ATR on Quality Control Check Report. (Apartments)

Control Check Report. Stage: After Finishing Stage III (Apartments)

CULMOLAIR RESIDENCY

Flat No	1107	Block no.	4
Flat Area	sq ft	Type	Deluxe / Luxury
Buyer Name	Mr. Srinivas		
Phone No.	9602210720	Email

Changes in kitchen platform: (mark on plan)

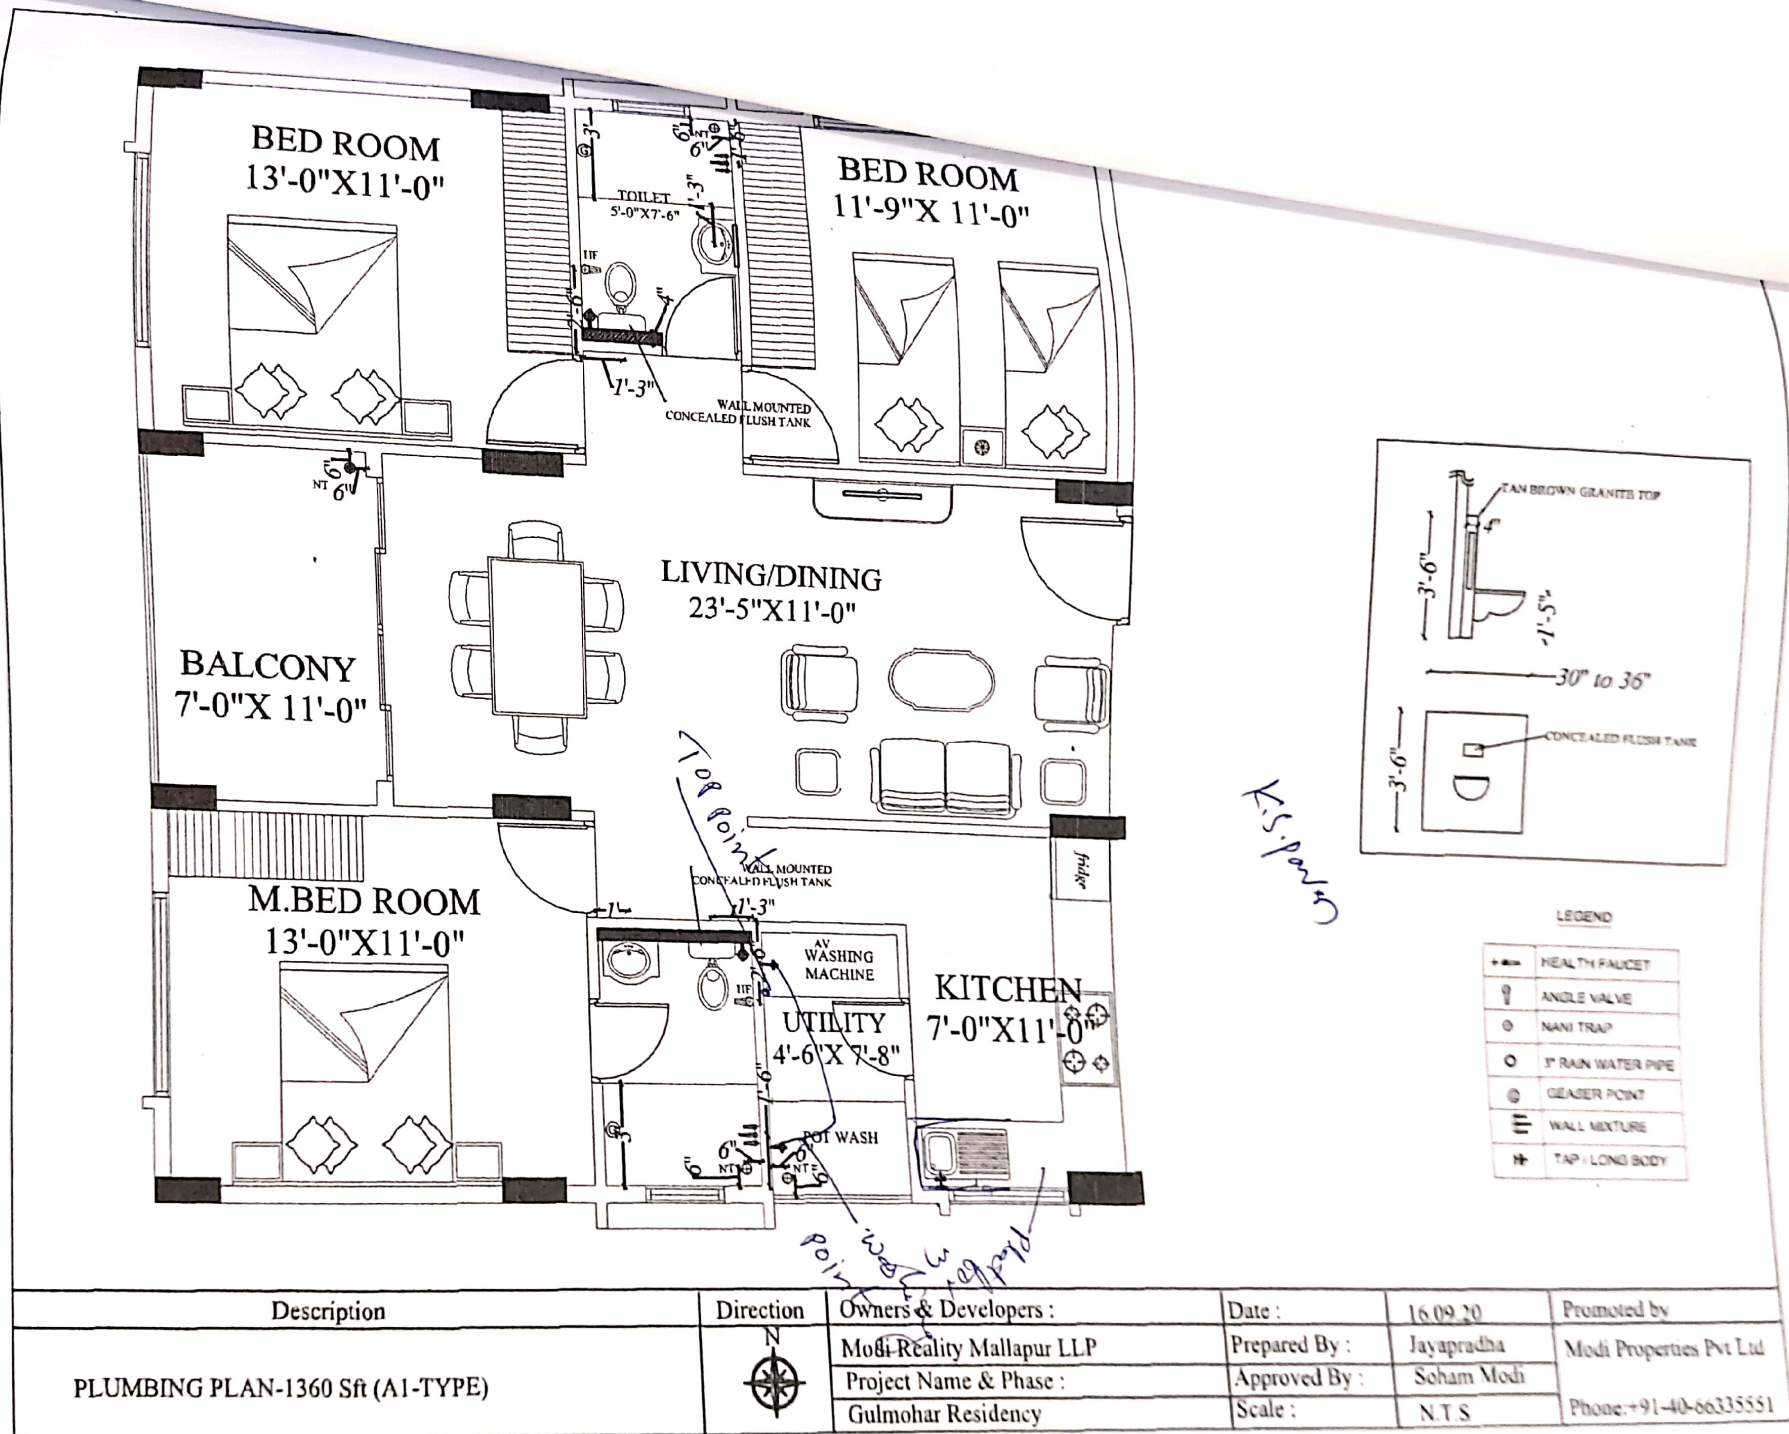
Need RLI platform & vision
to platform & call customer
to start with vegetable bowl.
